STAFF RECOMMENDATION 3641 Richland Avenue Lot 4, Richland Hall Development December 21, 2016

Application: New construction—infill and outbuilding
District: Richland-West End Neighborhood Conservation Zoning Overlay
Council District: 24
Map and Parcel Number: 10409028300
Applicant: Chad Gore, Mike Ford Builders
Project Lead: Melissa Baldock, melissa.baldock@nashville.gov

Description of Project: Application is to construct a new single family infill and an outbuilding. The addition's and infill's setbacks were approved by the Historic Zoning Commission in August 2016.

Figure 1. Lot at 3641 Richland Avenue

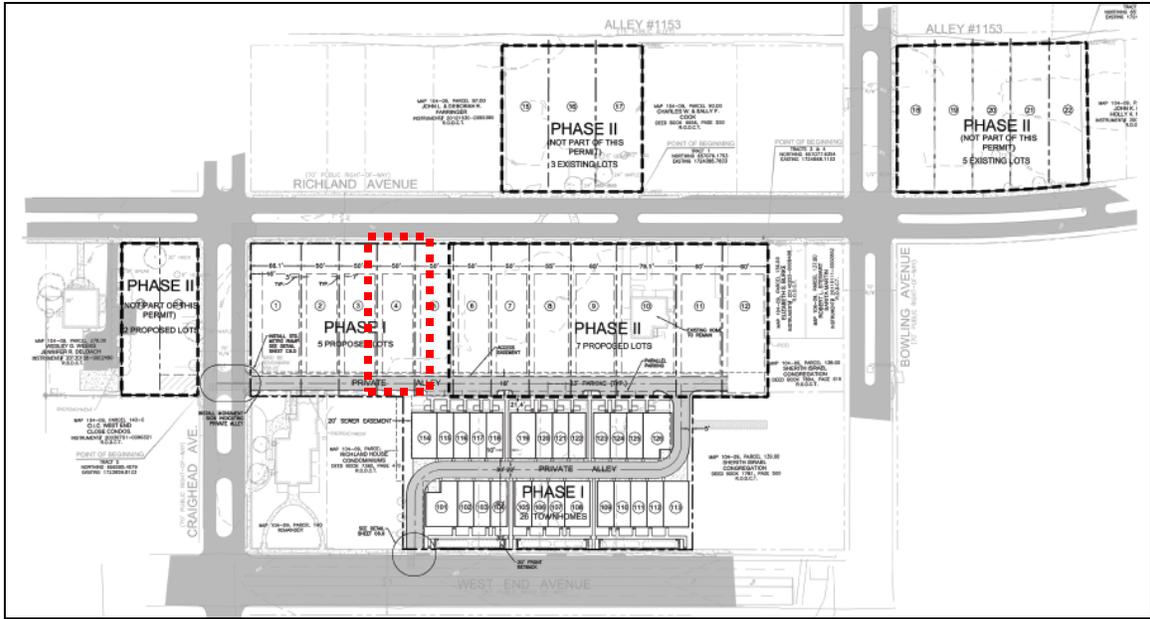
Background: 3641 Richland Avenue is a vacant lot that until recently was part of the Welch College (formerly the Free Will Baptist Bible College) campus (Figure 1). The College will be moving to a new location. In June 2015, the Metro Historic Zoning Commission approved a preliminary site plan for 22 new infill houses on the former campus, all located within the Richland-West Neighborhood Conservation Zoning Overlay (Figure 2). The Commission’s approval was contingent on the applicant returning to the Commission for approval of all infill design and site layout. MHZC so far has approved infill and outbuildings for Lots 1, 2 and 3 (3657, 3653, and 3647 Richland Avenue, respectively).

SITE PLAN

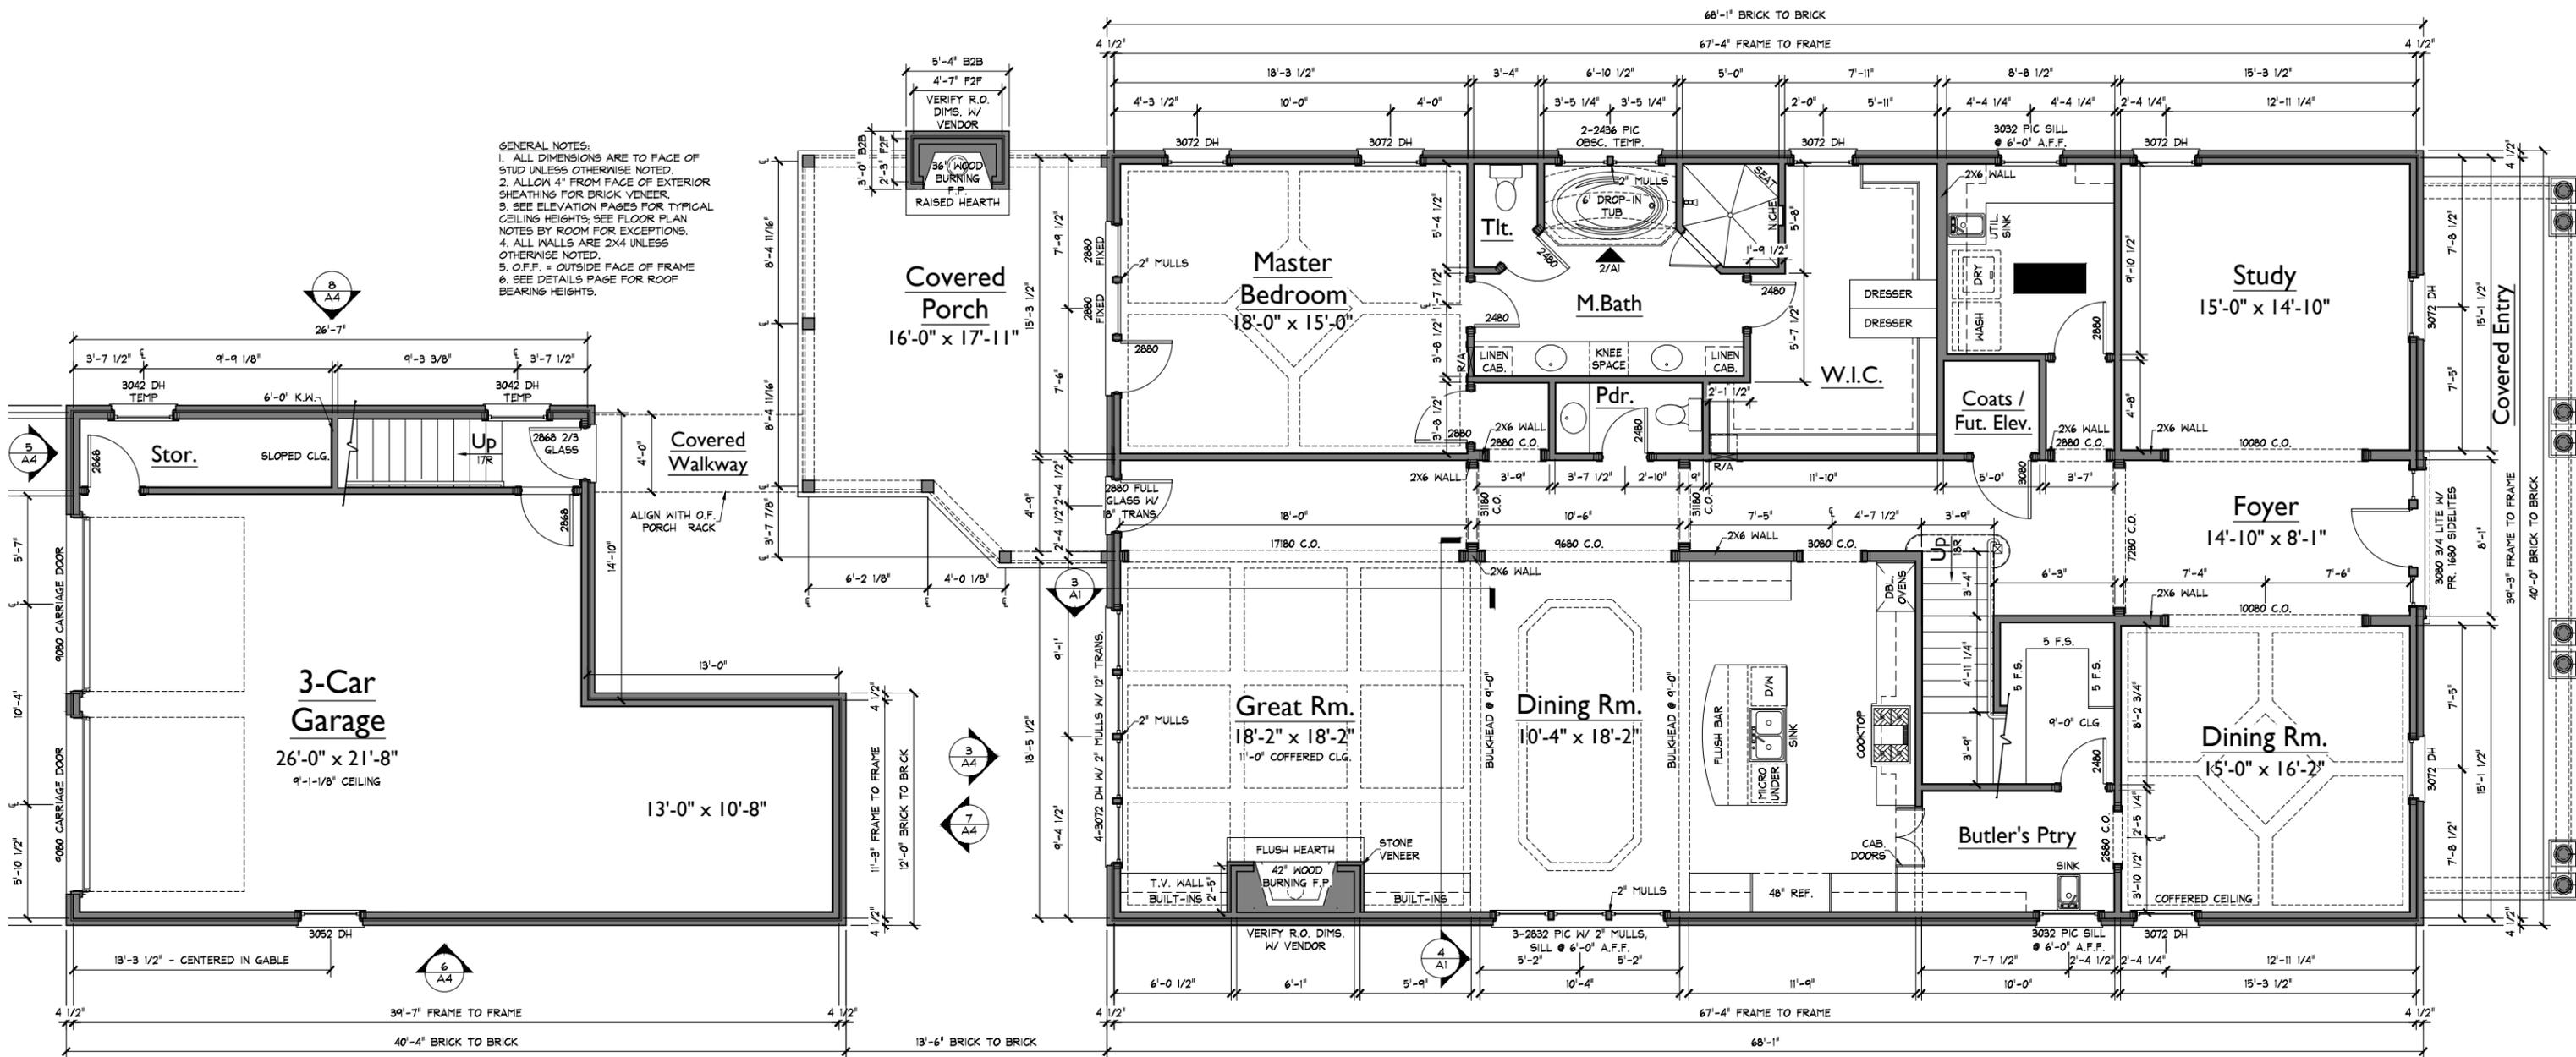
Setback & Rhythm of Spacing: In 2015, the Commission approved a plan that showed that the front-yard setbacks for new construction on the south side of Richland Avenue will be approximately forty-feet (40'), matching the context of the one historic building on that block, Davidson Hall. The proposed infill meets that front setback, and will line up with the infill houses already approved by the Commission for this development.

In August 2016, the Commission approved infill and an outbuilding on this lot that was just three feet (3') from the left side property line. As this is less than the base zoning setback of five feet (5'), the Commission made a setback determination. The re-designed infill and outbuilding will have the same three foot (3') left side setback. The applicant has indicated that the house on Lot 5, which has yet to be designed, will be at least seven feet (7') from its right side property line so that there will be ten feet (10') in between the infill houses on Lot 4 and Lot 5. On the right side, the house will be seven feet (7') from the side property line. The infill will be over seventy feet (70') from the rear property line. Staff finds that the proposed setbacks to be similar to the immediate historic context and to meet Section II.B.1.c. of the design guidelines.

The Commission typically requests to see at least twenty feet (20') between the primary structure and the outbuilding. The applicant is proposing just ten feet (10') in between the structures. The Commission has approved the distance of ten feet (10') in between the primary structures and the outbuildings for Lots 1, 2, and 3 of this development, and staff recommends that it be approved for Lot 4. The overall development is creating a new alley at the rear of the lots, which will make the back portion of the lot unavailable for building. Approximately the back thirty feet (30') of the lot is used for the alley. In addition, there is a utility easement in between the alley and the outbuilding. The outbuilding cannot be pushed any further to the rear because of the new alley and the easements on the property. Therefore staff finds that the distance in between the primary house and the outbuilding to be sufficient.

1 FRONT ELEVATION
1/8" = 1'-0"

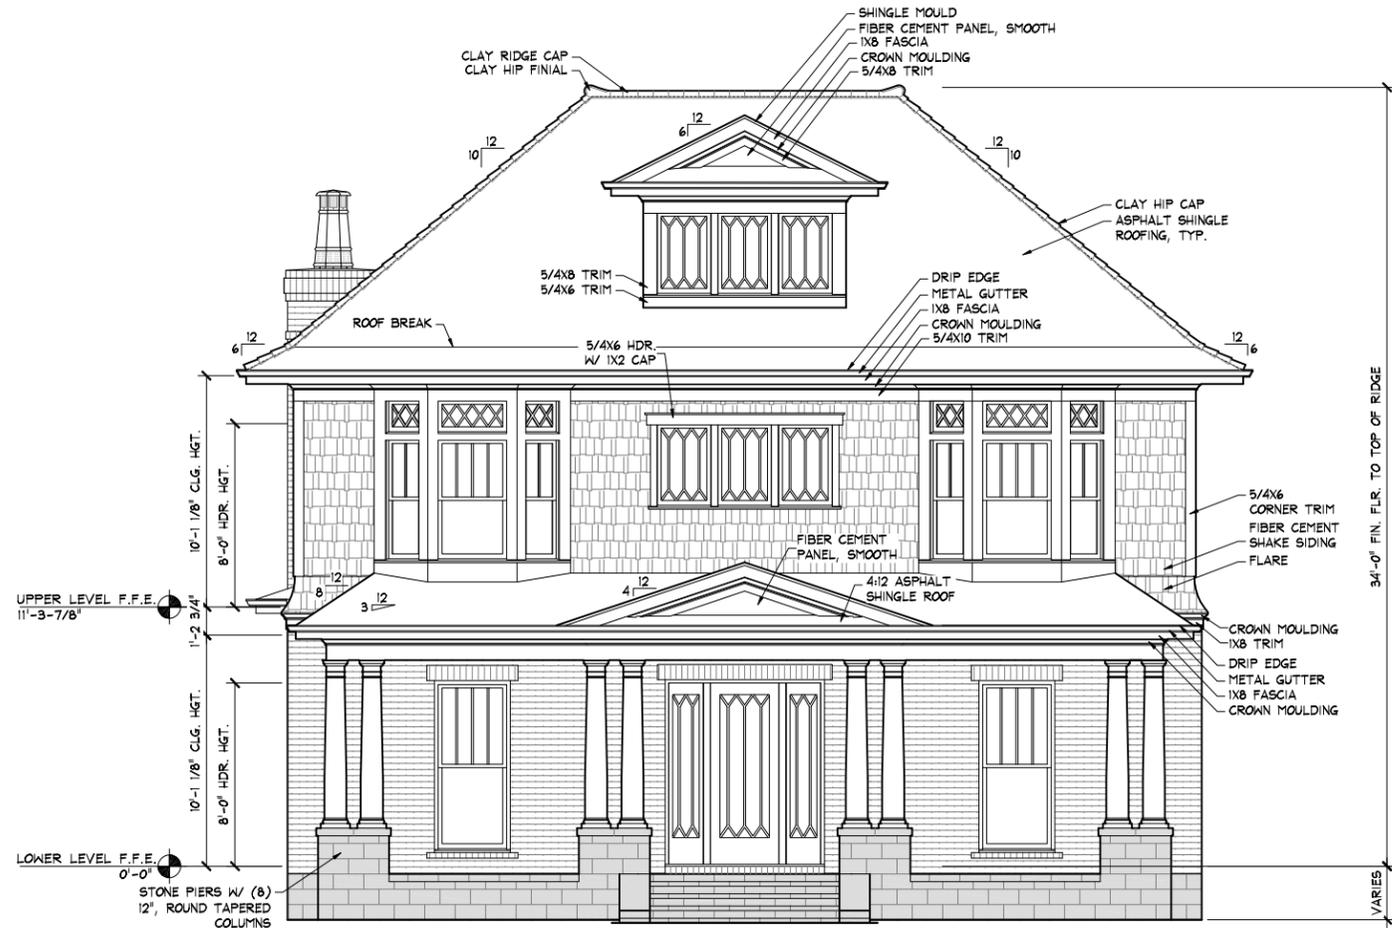
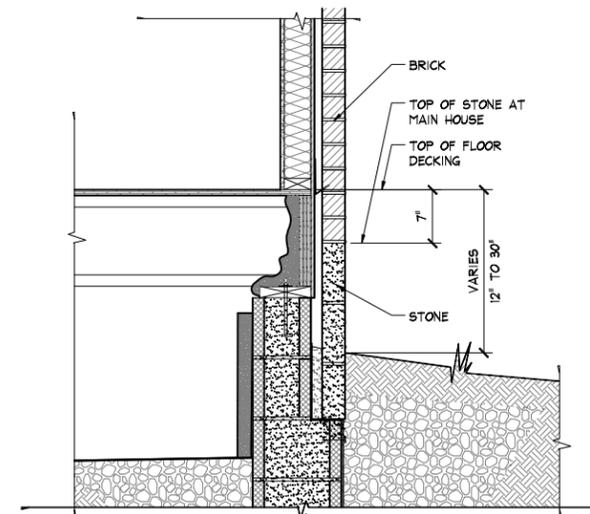
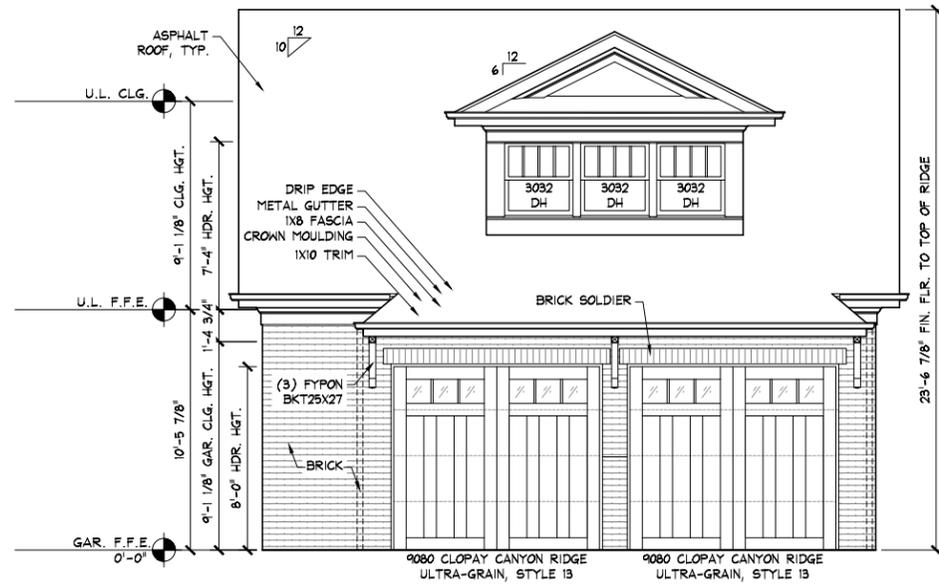
Height & Scale: The proposed infill will be two stories, with a maximum height of thirty-four feet (34') above the foundation, and approximately thirty-six feet (36') above grade. It will have an eave height of twenty-three feet, six inches (23'6") above the foundation. The foundation will be approximately two feet (2') tall. Staff finds that the proposed height is similar to the heights of historic houses in the immediate vicinity, which range from thirty to forty-four feet (30' – 44'). It is also no taller than the heights of the infill houses approved for Lots 1, 2, and 3 of this development.

Staff recommends verification of the construction height of the foundation and floor systems in the field to ensure that the finished floor line of the new construction is compatible with the historic context. With this condition, staff finds that the height and scale meet Sections II.B.1.a. and II.B.1.b. of the design guidelines.

Roof form: The infill’s primary roof form is a hipped roof with a 10/12 pitch. A 6/12 hipped roof will tie into the back of the main hip roof of the house. On the front there is a gabled dormer that is set back two feet (2’) from the wall below. The front porch has a hipped roof with a slope of 3/12; the roof contains a 4/12 pediment at the center. The rear porch is a 4/12 hip. Staff finds that the proposed roof forms are appropriate for a two-story infill house in the overlay, and finds that the roof forms meet Section II.B.1.e. of the design guidelines.

Proportion and Rhythm of Openings: The proposed windows on the infill are generally twice as tall as they are wide, thereby meeting the historic proportion of window openings. There are no large spaces of wall without a window or door opening. Staff finds that the infill’s proportion and rhythm of openings meet Section II.B.1.g. of the design guidelines.

1 GARAGE FRONT ELEVATION
1/8" = 1'-0"

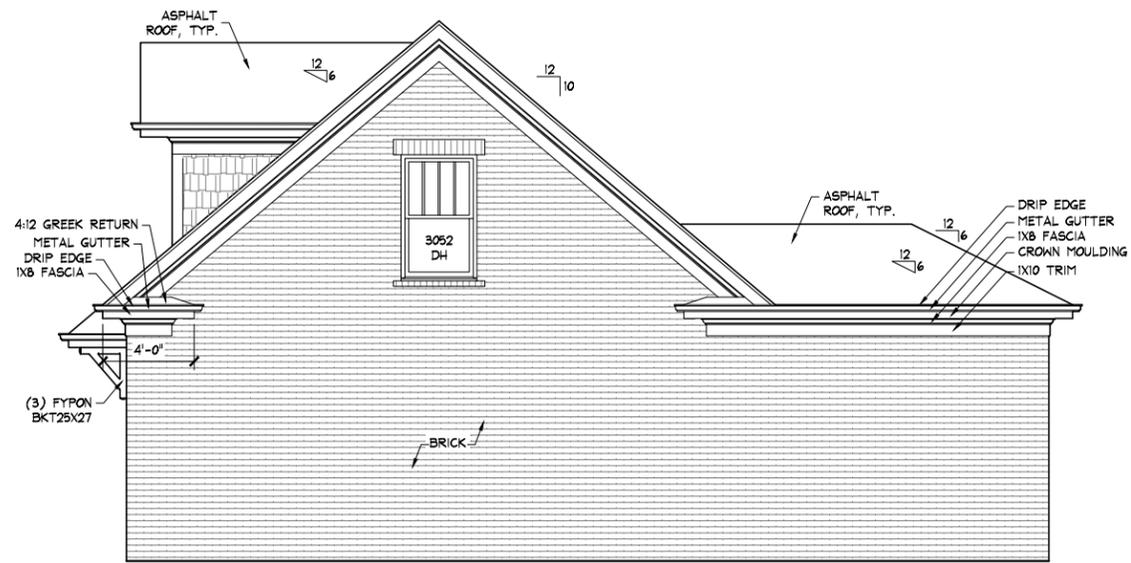
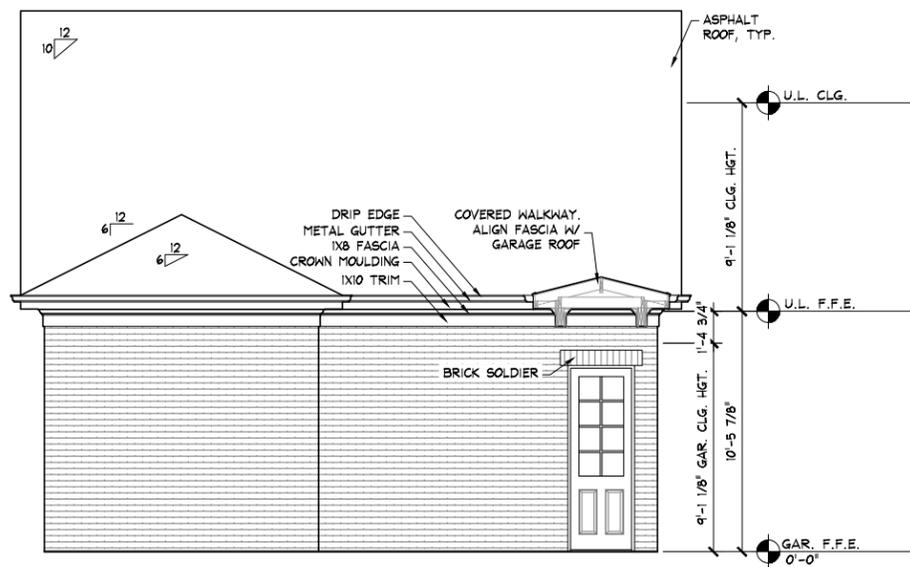
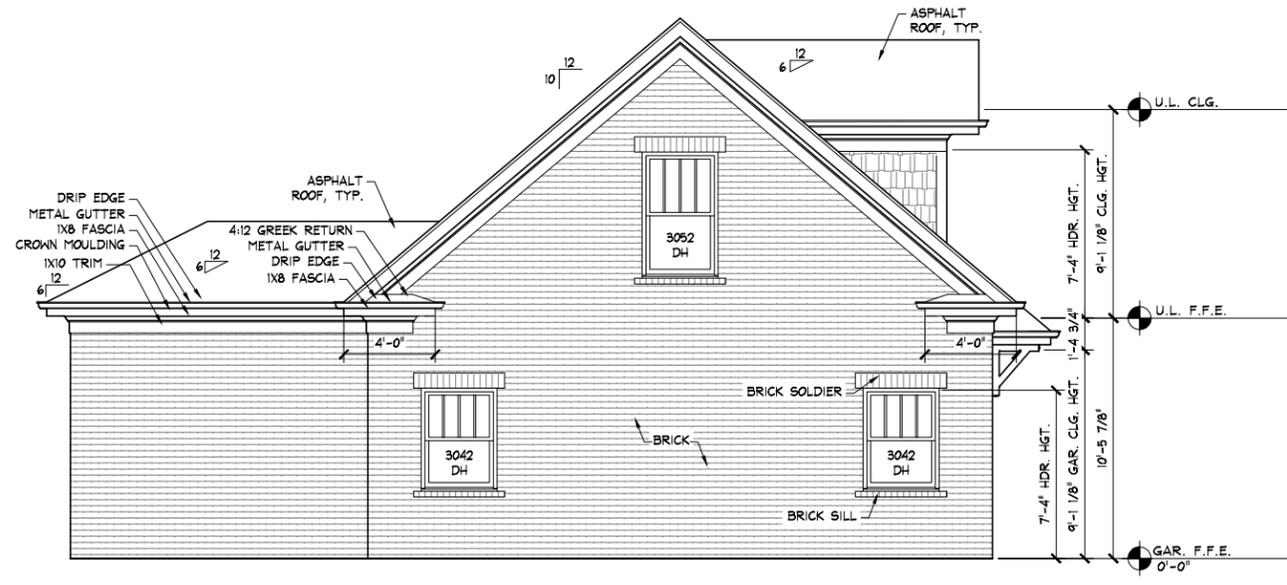
Infill	Potential maximums (heights to be measured from grade)	Proposed (should be the same or less than the lesser number to the left)
Ridge Height	36'	25'	23'9"
Eave Height	23'6"	2 story 17'	10'

Lot is more than 10,000 square feet	50% of first floor area of principle structure	Proposed footprint
Maximum Square Footage	1,000 sq. ft.	≈1300	894 sq. ft.
